ARTICLE 14. ONE AND TWO FAMILY DWELLING CODE

Rule 2.1. CABO One and Two Family Dwelling Code; Amendments

FIGURE R502.8
CUTTING, NOTCHING AND DRILLING

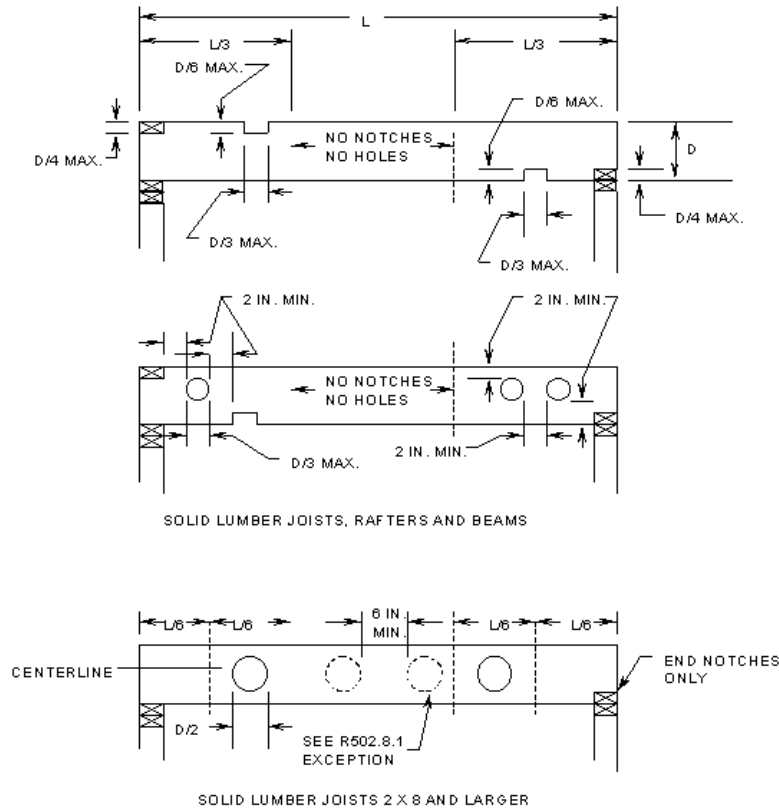
Sec. 88. Delete FIGURE R502.8 and substitute as follows: FIGURE R502.8:

FIGURE R602.6(2)
NOTCHING AND BORED HOLE LIMITATIONS FOR INTERIOR NONBEARING WALLS

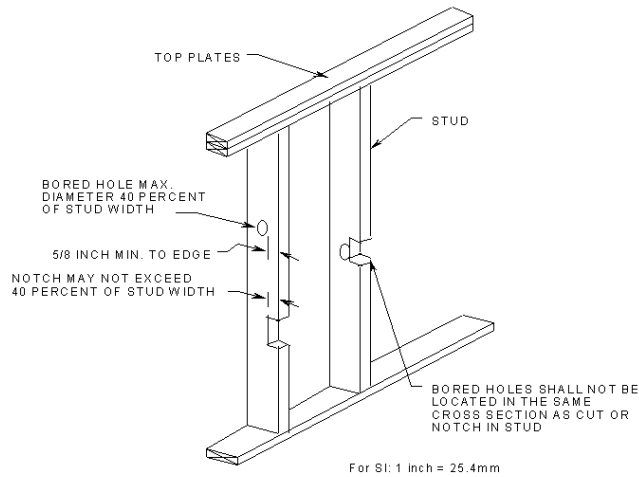
Sec. 95. Delete FIGURE R602.6(2) and insert FIGURE R602.6(2) to read as follows:

FIGURE R602.10.5(2)
GARAGE DOOR BRACED WALL PANEL FOR USE WITH CONTINUOUSLY SHEATHED WALLS

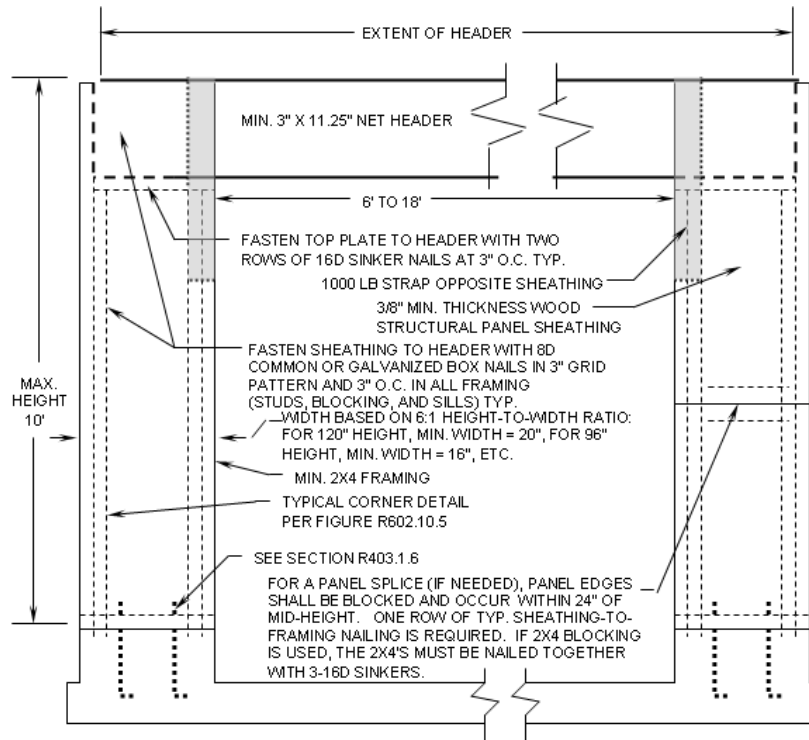
(4) Add FIGURE R602.10.5(2) to read as follows:

FIGURE R703.7.6(1)

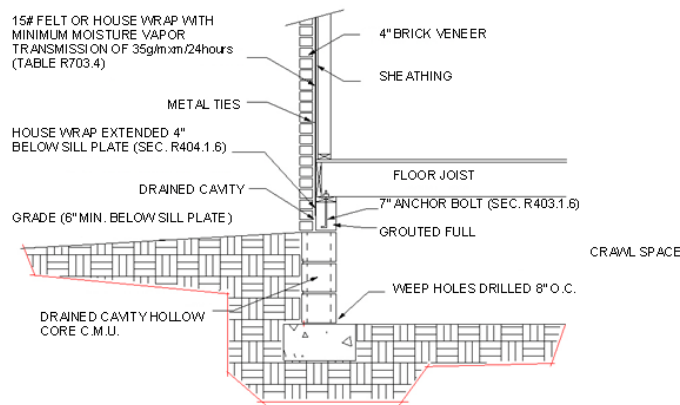
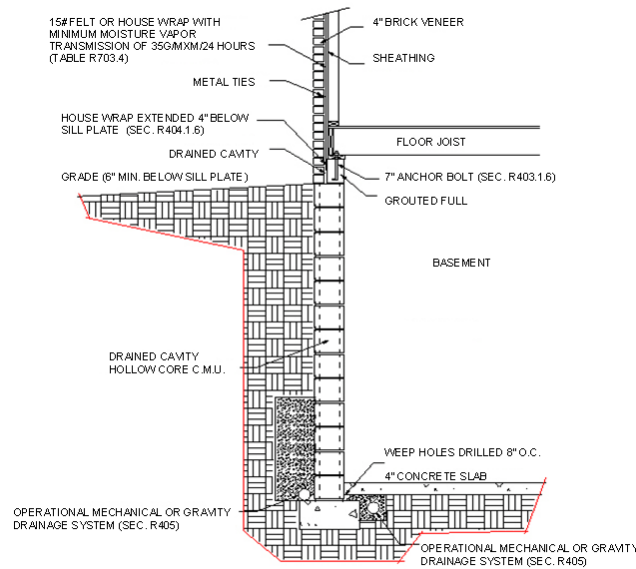
Sec. 121. Delete the title and text of SECTION R703.7.6 and substitute as follows: R703.7.6 Drained cavity. The 3/4 inch (19 mm) air cavity shall be drained to the exterior of the structure at intervals of not more than 33 inches (838 mm) on center. Each drain shall be not less than 3/16 inch (4.8 mm) in diameter, located immediately above the flashing. For dwellings with crawl spaces, the air cavity may be drained as shown in FIGURE R703.7.6(1). For dwellings with basements, the air cavity may be drained as shown in FIGURE R703.7.6(2).

FIGURE R1001.6
Chimney Termination

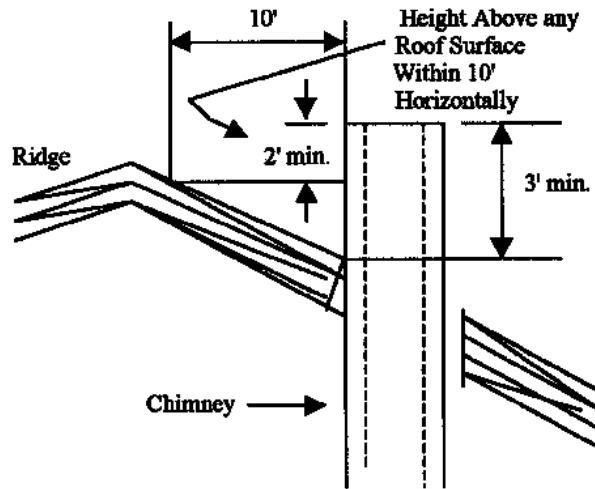
Sec. 135. Add FIGURE R1001.6 as follows:

FIGURE E3801.4.1

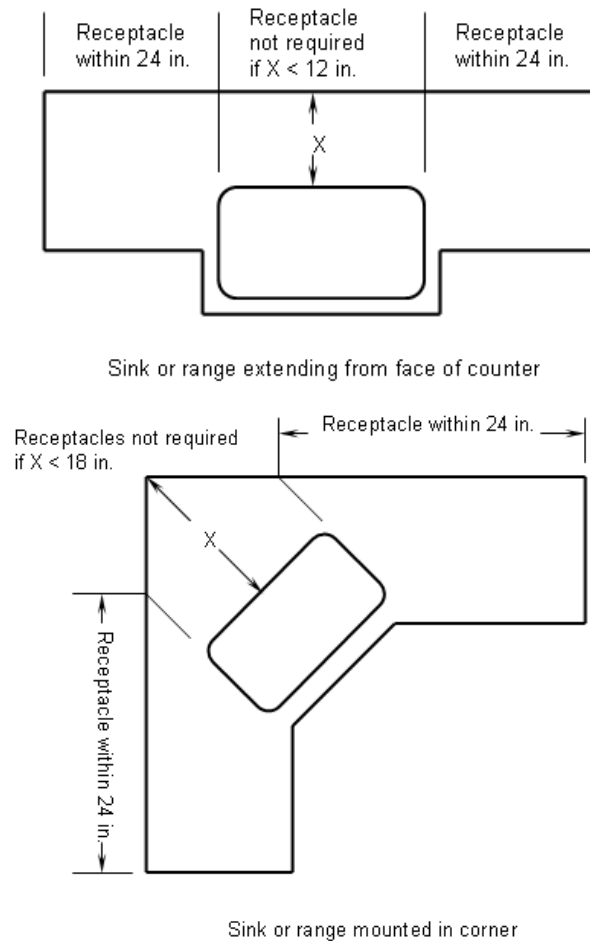
Sec. 229.5. (a) After SECTION E3801.4.1, add an exception to read as follows: Exception: Receptacle outlets shall not be required on a wall directly behind a range or sink in the installation described in FIGURE E3801.4.1.

(b) After SECTION E3801.4.1, add FIGURE E3801.4.1 as follows:

Figure 4-2
Maximum Allowable Wall Slope

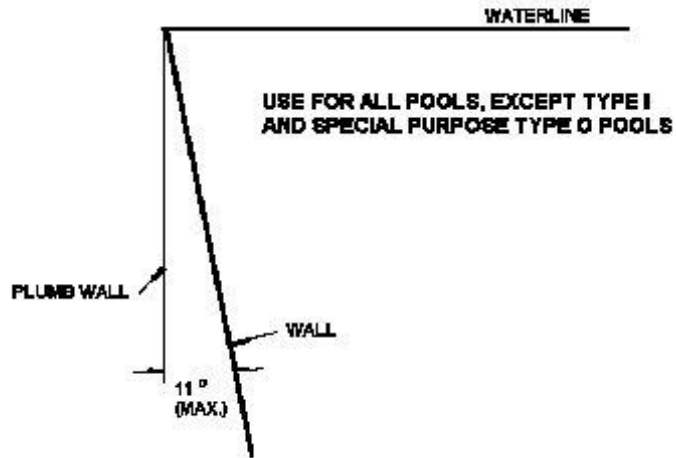
(6) S4210.6 This section contains Figure No. 4-2, a maximum allowable wall slope.

Figure 4-5
Minimal Dimensions - Type 1 Pool

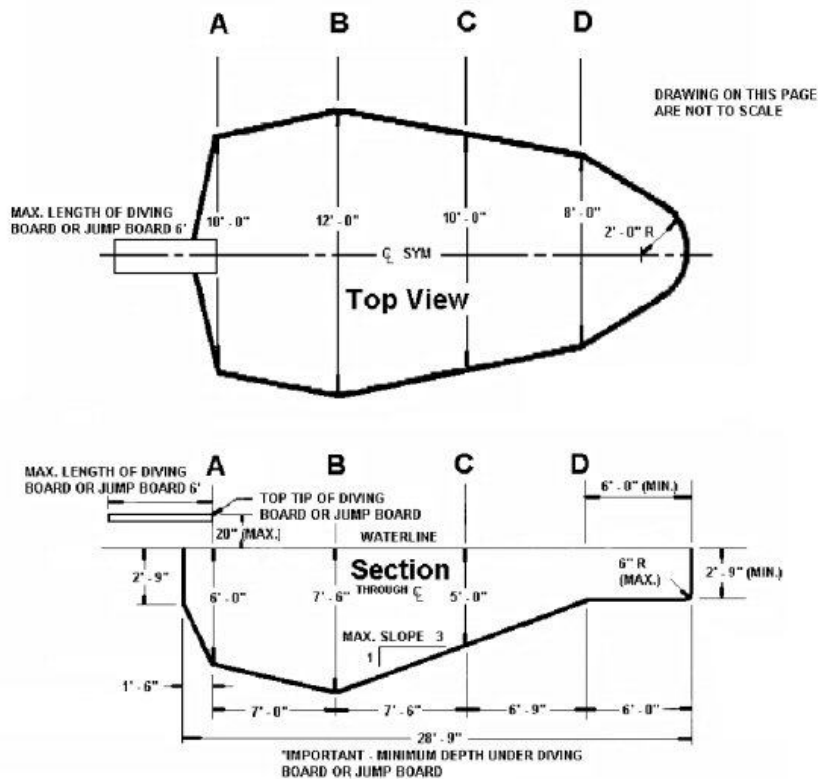
(9) S4210.9 This section contains Figure No. 4-5, minimum dimensions for a Type I pool.

Figure 4-10
Shallow End Detail

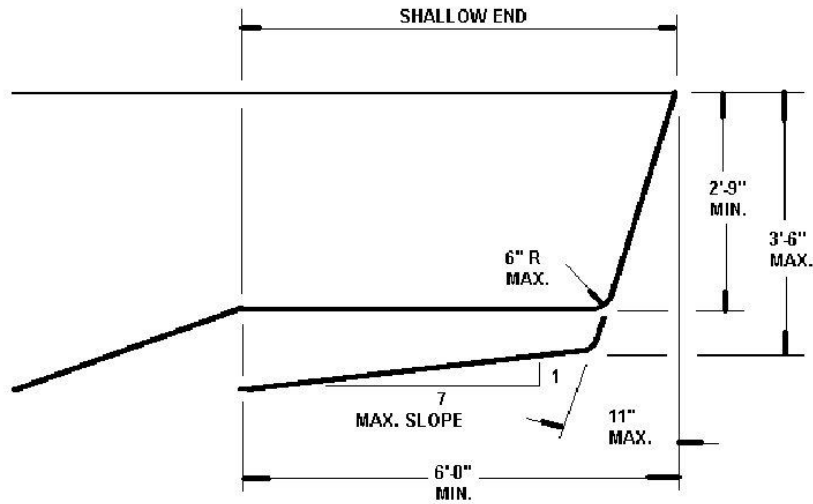
(14) S4210.14 This section contains Figure No. 4-10, shallow end detail for pool Types II through V.
